**Our Case Number:** ABP-317660-23

**Re:** Bus Connects Kimmage to City Centre core bus corridor scheme  
Kimmage, Dublin

## St Martins Residents Association

Ref: An Bord Pleanála Case Ref: 317660  
Bus Connects Core Bus Corridors / 11 Kimmage to City Centre Core Bus Corridor Scheme.

**Gate No 1**

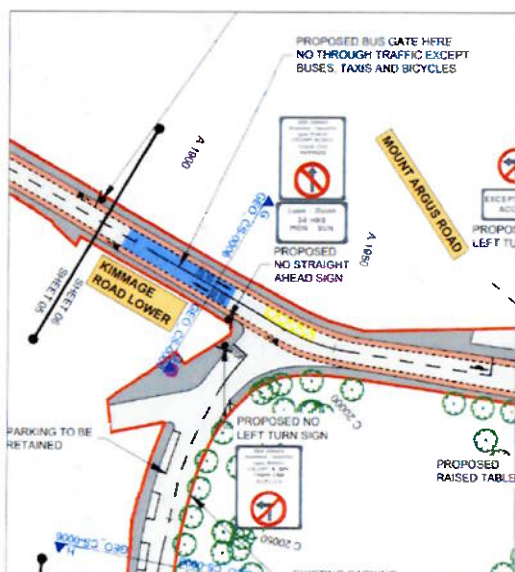
The proposed Bus Gate at Ravensdale Park North of the Kimmage Cross Roads (Sheet No 1, EIAR Volume 1 General Arrangement Drawings)

*“The Proposed Bus Gates in both directions are to be operational between the peak hours of 06:00-10:00 and 16:00 -20:00 Monday to Sunday.”*

The residents welcome that the operational times have been altered to peak times only, but submit that the inclusion of Saturdays and Sundays to the peak times is unnecessary, too restrictive and disproportionately affects the residence living in the vicinity.

There is no impact assessment, or consideration / analysis of the consequential impact on the surrounding area of the restrictions on the residents, whose homes are located within the bus gate locations.

**Gate No 2**

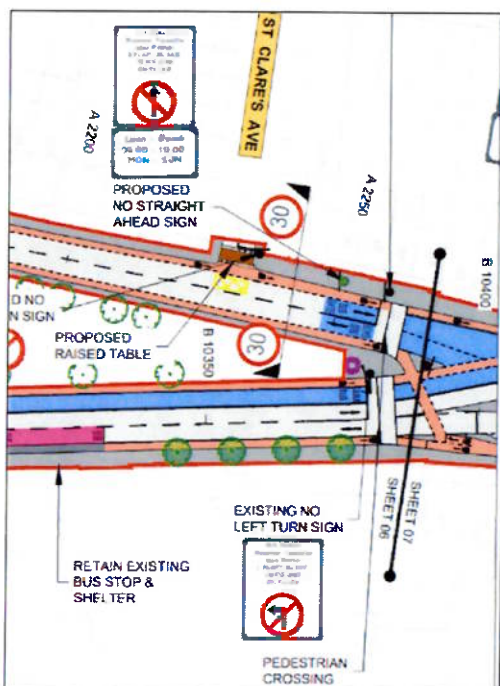
The proposed Bus Gate at the Junction of Harolds Cross Park (Sheet No 6, EIAR Volume 1 General Arrangement Drawings)

The documents appear to Propose that the Bus Gates in both directions are to be operational 24 hours Monday to Sunday. This is overly and disproportionately restrictive given that the road will only be used by residents for local access. This denies residents access at all times to use their cars to access the Cemetery, Our Lady's Hospices and other amenities in Harolds Cross.

We would request the following amendment to this gates operational times –

That this gate operates at peak times only in the same way as ( Gate No 1 in our report at Ravensdale), In addition as requested above that the Saturday and Sunday hours be removed.

### **1.4 Bus Gates**

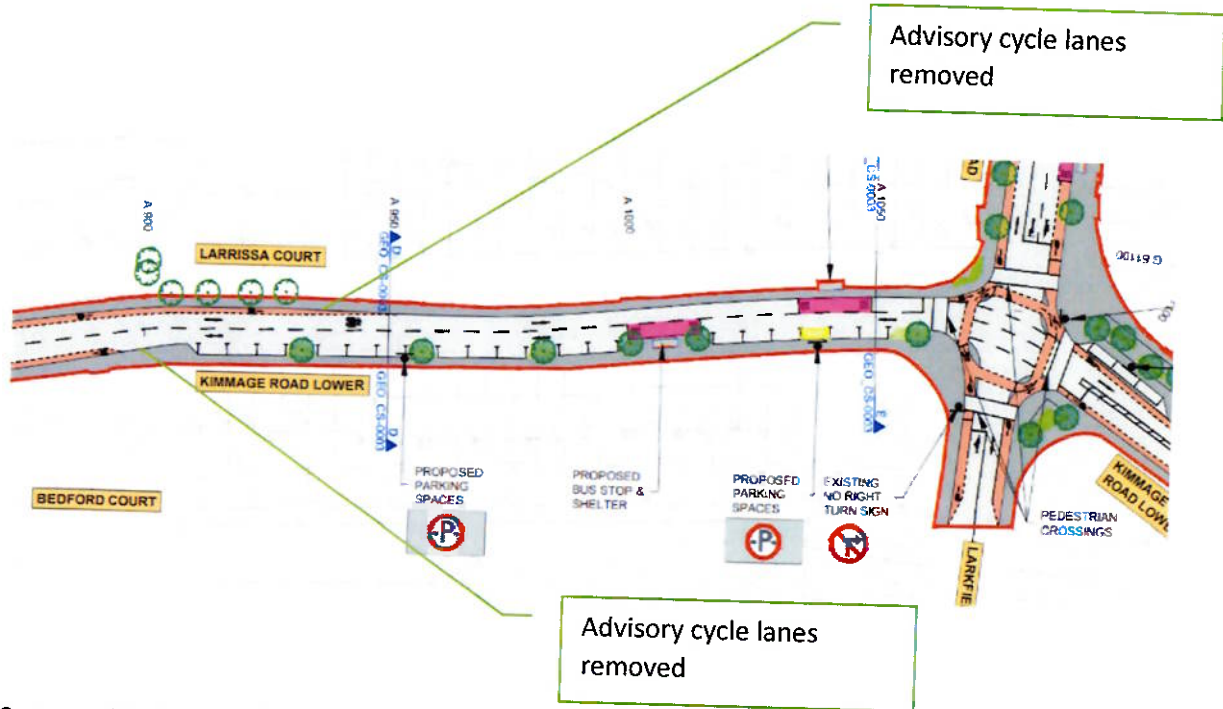
We would request the 3 Bus gates operational times be reviewed, we would submit that clear operational times have not been indicated on the general arrangement drawings or reports.

We would submit that off peak time access could be allowed to facilitate residents living between the 3 No gates.

We would submit that Saturday and Sunday access should be allowed.

The omission of the proposed operational times of the southern bound bus gate needs to be addressed to allow residents assess fully the scheme.

(Sheet No 3, EIAR Volume 1 General Arrangement Drawings)

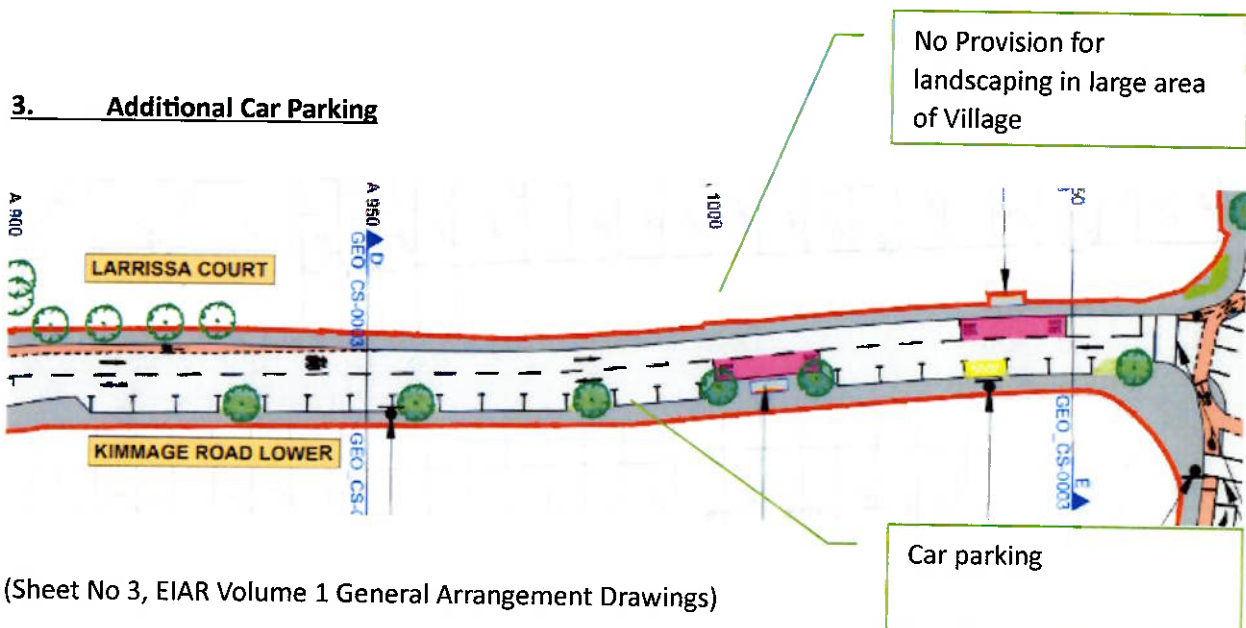
There is no impact assessment on the removal of these advisory lanes, no consideration or analysis of the consequential impact on the cyclists using the lanes and how the removal mid route will be dealt with. We would submit that all existing advisory cycle lanes be retained and not altered with in bus gates as it is stated in the EIAR but is contradicted in the general arrangement drawings.

We note on the general arrangement drawings that an additional 17 No car parking has been included on the Southern route outside the existing properties Nos 176 to 220 Kimmage Road lower.

It appears from the general arrangement drawings that the cycle lanes have been omitted to facilitate these additional spaces, as discussed above -Provision of cycle lanes (Sheet No 3 Volume 1 General Arrangement Drawings).

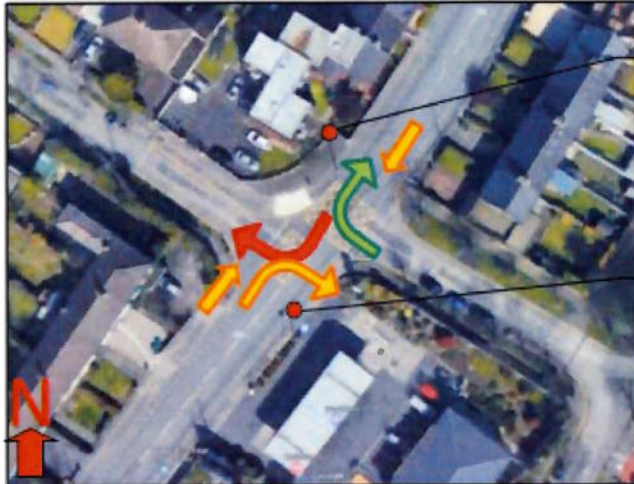
The proposal to widen Kimmage Road lower to 2 No bus lanes and 2 No car lanes along with the installation of a new bus stop located outside the apartment building on Kimmage Road Lower together with the elimination of the existing designated cycle lane will all have a negative impact. The impact in particular on the staggered junctions of St Martins / Kimmage Road lower/ Kimmage Close has, in our opinion, not been given sufficient consideration or design review. In fact, there is no mention of any traffic control measures to make the junction safe for all users or how pedestrians and cyclists from St Martins are to be facilitated with in the proposals.

We draw particular attention to the safe entrance/ exit to and from our estate onto Kimmage Road lower for all users, be they pedestrians, cyclist, motor bikes or cars, in particular the turning right ( travelling South ) out of the estate and turning right ( travelling West ) into the estate. Not only will residents have to manage 2 lanes of traffic to make this manoeuvre, they will also, as is now the case, have to manage the various other vehicles entering and existing Kimmage Close, the playing fields and the Petrol station. This will further be impacted by the proposed relocation of the bus stop – reducing sightlines south of Kimmage Road Lower.

The proposal as it stands will unduly impact the residents of the estate in trying to enter and exit the main road, either via car, foot or cycle and in our opinion gives rise to serious health and safety design issues.

There does not appear to be any attempt to try and redesign the junction with traffic control measures. We would contest that this junction has been completely overlooked. We would also highlight that the introduction of a bus lane will give other road users a lane to overtake on the inside while another car is turning right.

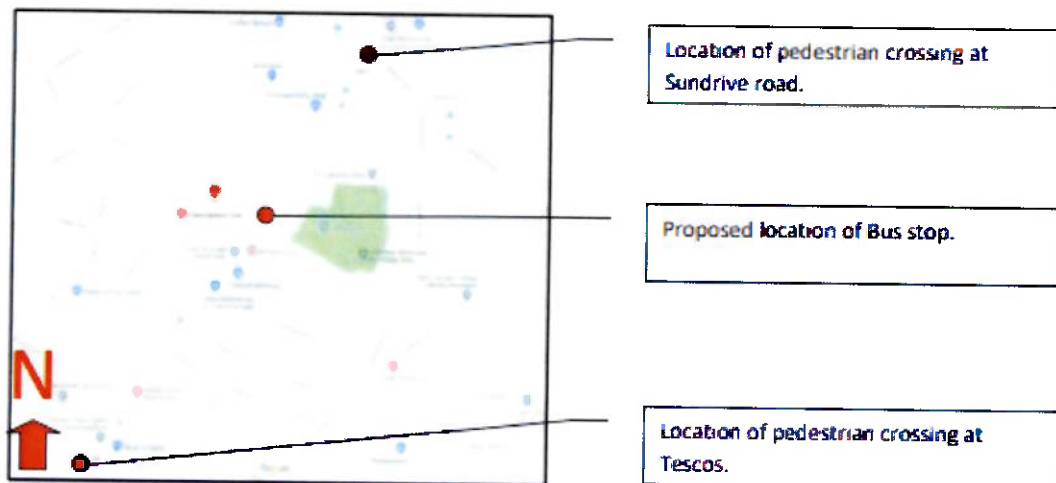
We highlight below a scenario, which we hope will assist in illustrating the issues with the junction. Bikes/Cars turning right into St Martins ( Red arrow) Cars turning right into petrol station ( Orange arrow) are overtaken on the inside (proposed Bus lane ) by other motorists causing more congestion

Proposed location of Bus stop will obscure the view of cars existing St Martins estate causing safety hazard.

Proposed widening of Kimmage Road Lower to 4 lanes encouraging cars to use the bus lane to overtake turning cars making junction more hazardous.

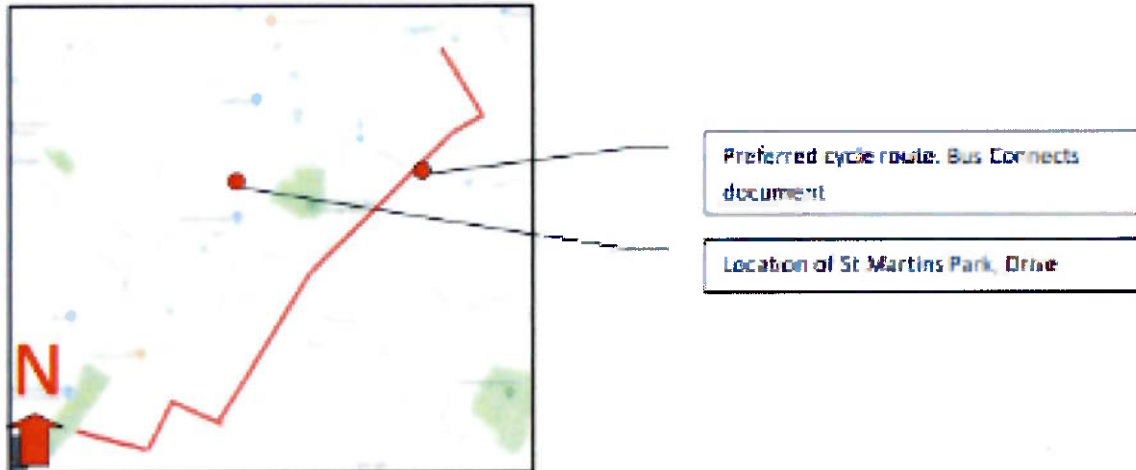
The removal of the designated cycle lane and the proposed cycle route does not take into account the numerous houses along Kimmage Road lower and St Martins or Kimmage Close who will not be able to safely access the cycle route. Children and adults cycling to school or work will now have to cross the 4 lanes proposed for lower Kimmage road and manoeuvre their way through traffic to access the cycle lane.
